## PLANNING COMMISSION STAFF REPORT

Merrimac  
**PLNSUB2009-00417**  
Planned Development  
38 West Merrimac  
June 10, 2009

Nathan Anderson of City and Resort Properties

**Attachment D**  
Transportation Division redlines

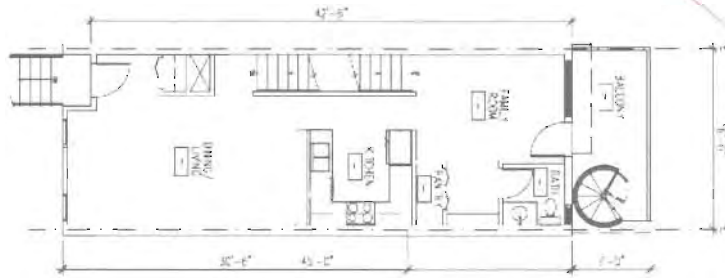
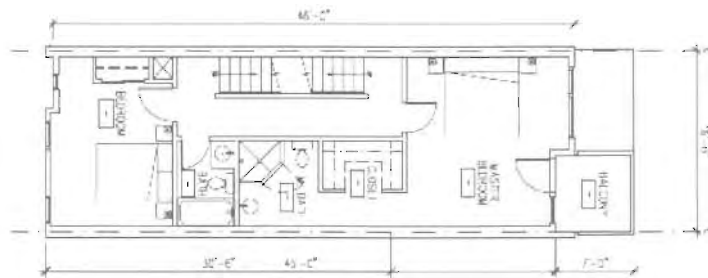
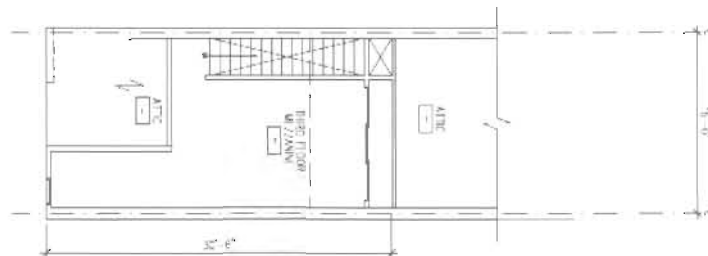
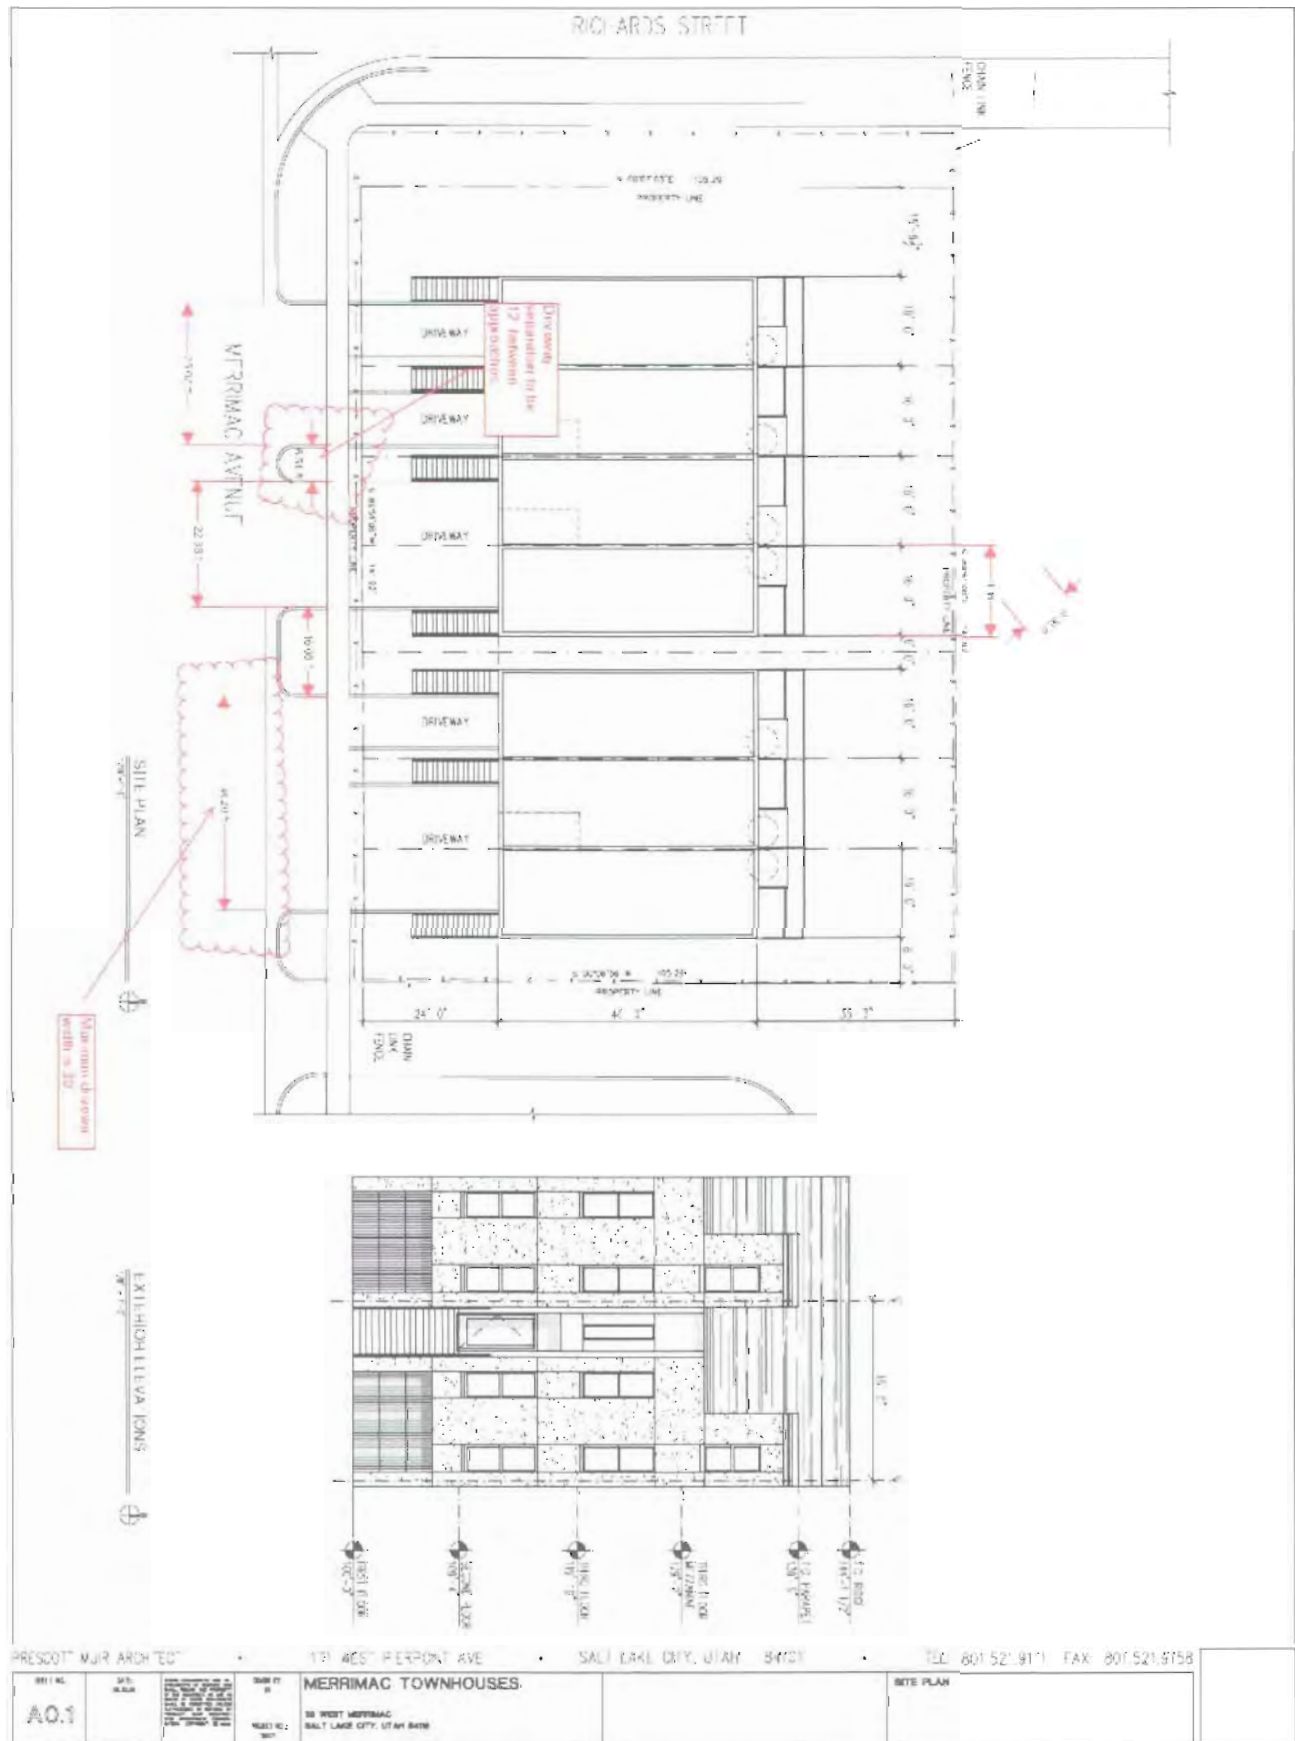
Existing vehicle  
parking space  
is not to be  
used for  
storage.
